**Re: McMinnville Water & Light (00497)
Tracer Study (PR# 139-2015)
Final Approval**

August 2023 McMinnville Norman Scott WTP Finished Water Tracer Study --McMinnville Water & Light – PWS ID 00497

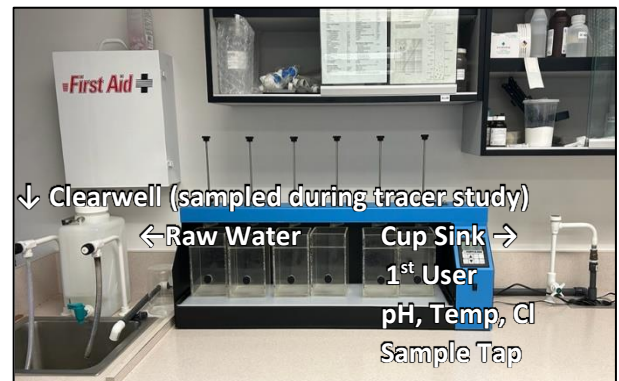
A contact time of 71 minutes represents the contact time of 33 minutes through the clearwell (determined during the August 30, 2023, tracer study) plus an additional 38 minutes of contact time using a peak flow of 10.1 gpm through the piping from the clearwell to the office cup sink. The pipeline calculations shown below were sent as an e-mail attachment from Craig Massie with Jacobs on May 30, 2024.

Contact Time = [Total Volume, gpm] / [Flow, gpm] = 37.63 minutes

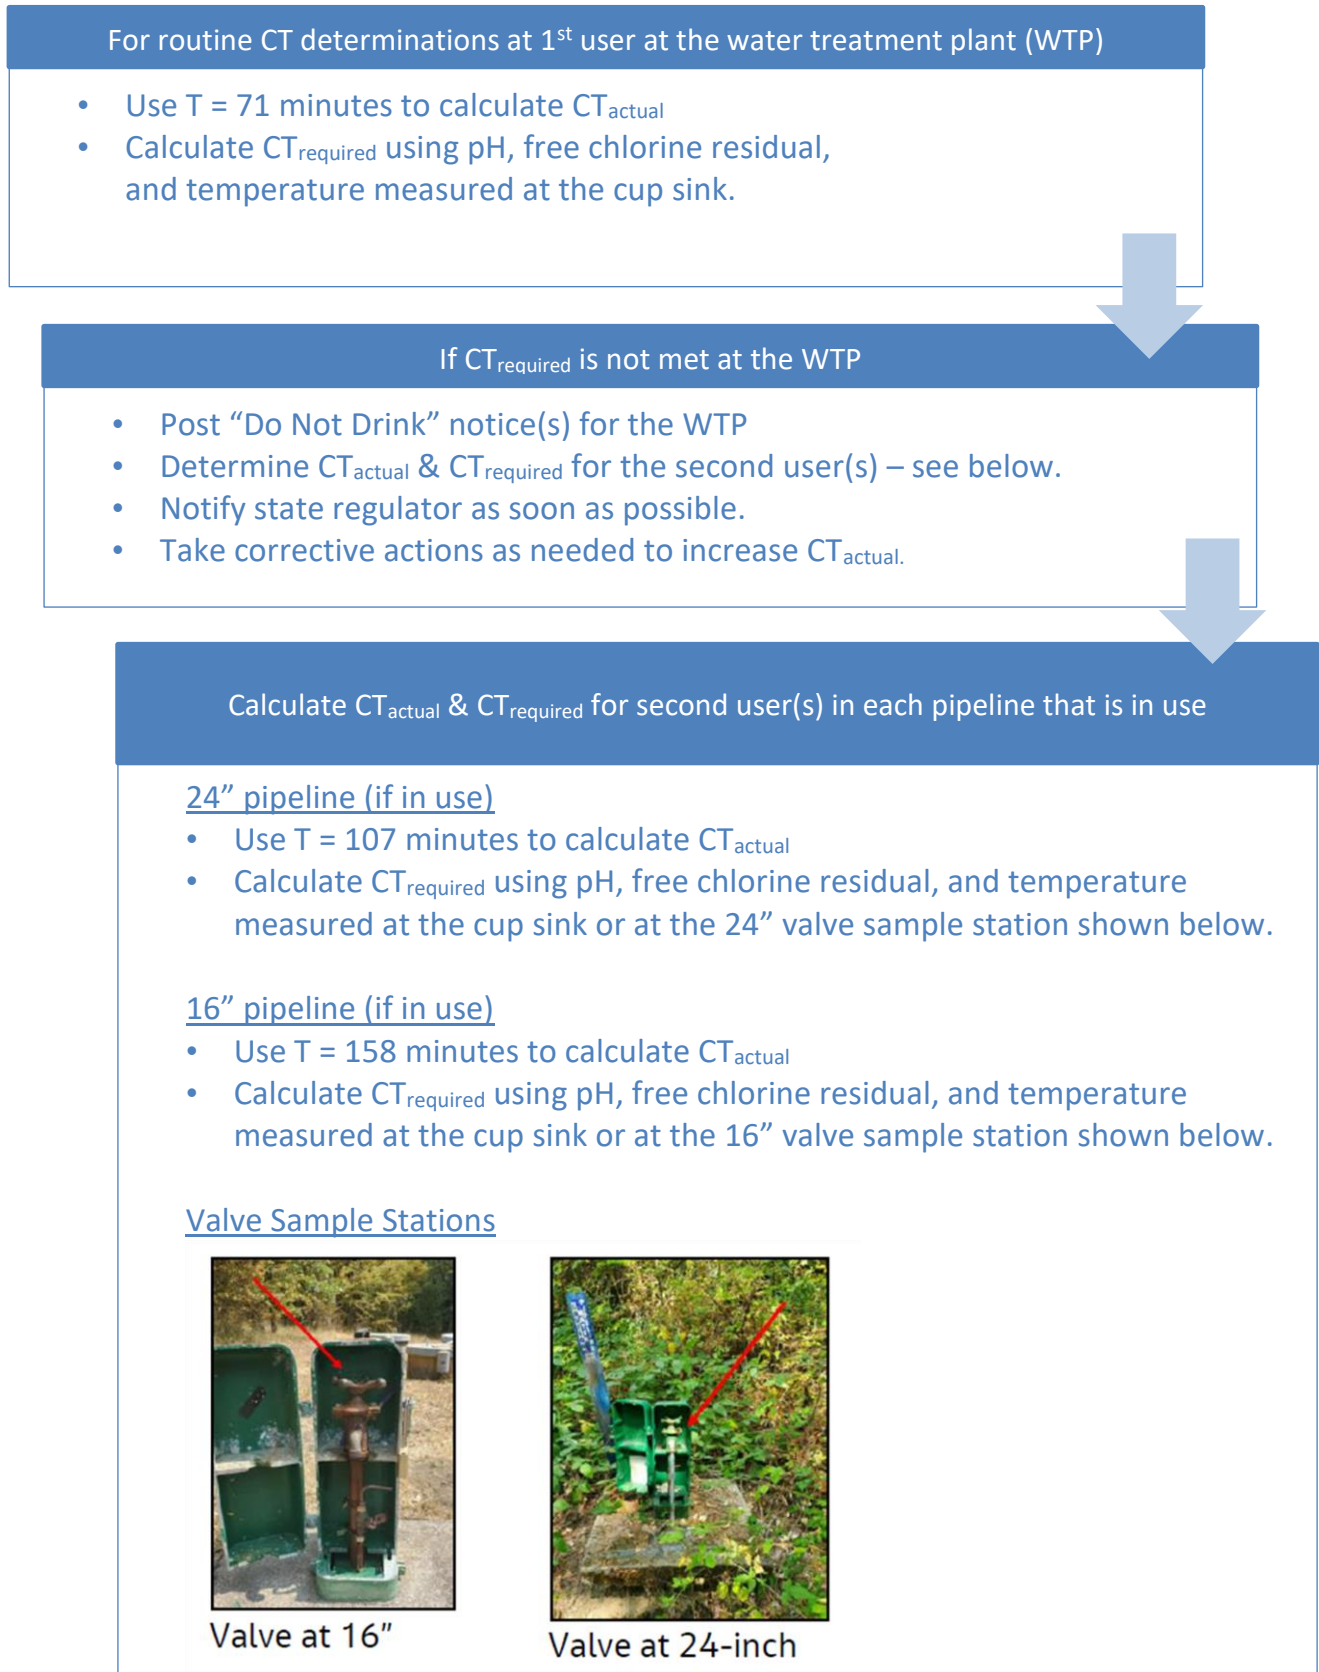
The flow chart below shows some of the follow-up actions needed should the required CT not be met at the treatment plant.

Figure 2. Normalized Fluoride Concentration with Time at Four Sampling Locations.

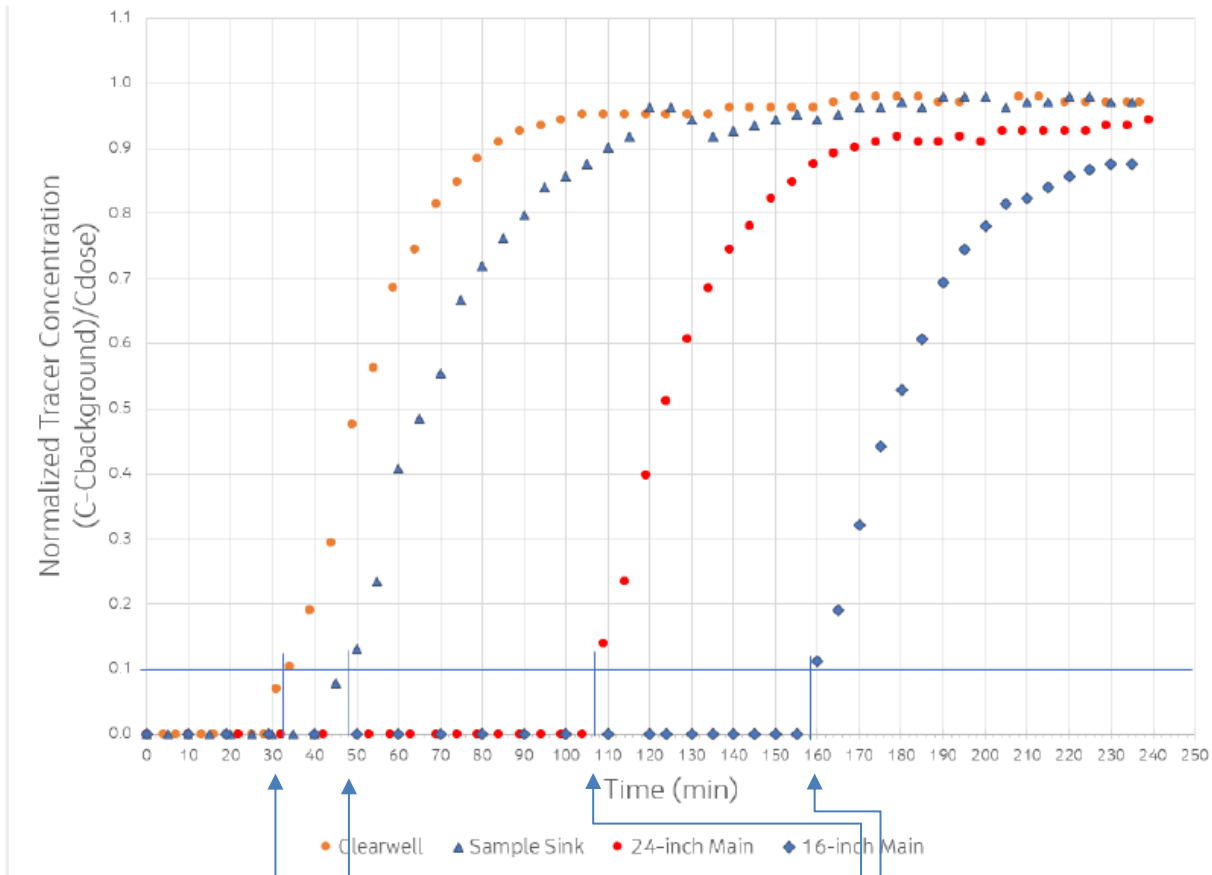
Contact times of 33, 48, 107, and 158 minutes were determined with a tracer study performed August 30, 2023:

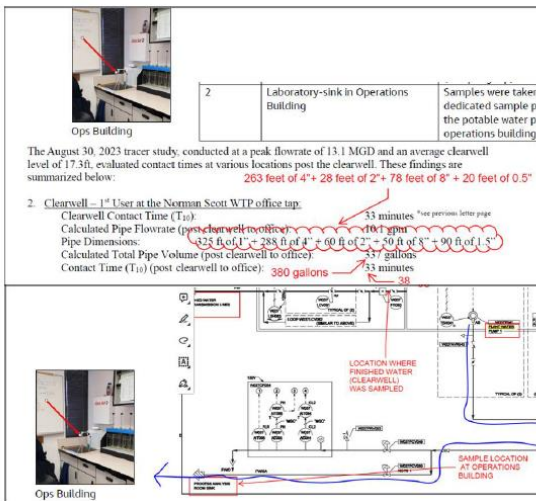
- 1) Do the piping calculations you provided represent the path of water shown below to the lab sink identified in the tracer study as sampling location #2? NO, THE SINK IS THE CUP SINK JUST TO THE RIGHT AND OUT OF THE PICTURE. THE SAMPLE SINK IN THE PICTURE RECEIVES FROM VIA A 0.5 INCH LINE DIRECTLY FROM THE CLEARWELL POTABLE WATER PUMPS AND DOES NOT GO THROUGH THE OVERSIZED PIPING THAT THE CUP SINK POTABLE WATER FEED LINE PASSES THROUGH.

The sample location for measuring CT parameters (chlorine residual, pH, and temperature) is to be at the WTP cup sink shown below.

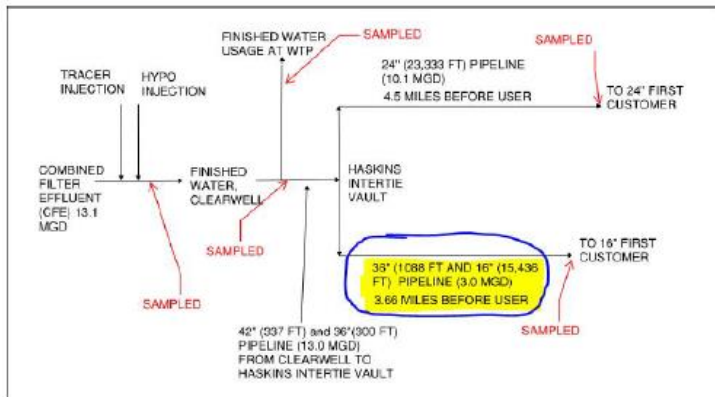
- 3) Do the baffling factors indicated for the "segment" represent the entire flow path (e.g., the baffling factor of 0.90 for the 24" main includes the flow through the clearwell and the 24" pipe) rather than just the individual segment (e.g., pipeline only)? **PIPING ONLY**

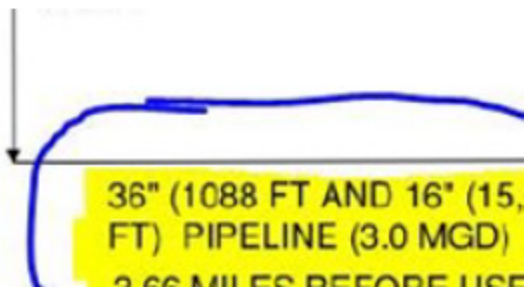
- 2) Notify you regarding the following error found in Figure 1 of the 12/18/23 final tracer study report: The 1,088-ft of 36” pipe in the diagram shown above should be 3,263-ft.

So the 1,088-ft of 36" pipe in the diagram shown below should actually be 3,263-ft then? YES

Yes, I see that now that the 18,700 (3,263 + 15436 = 18,699)
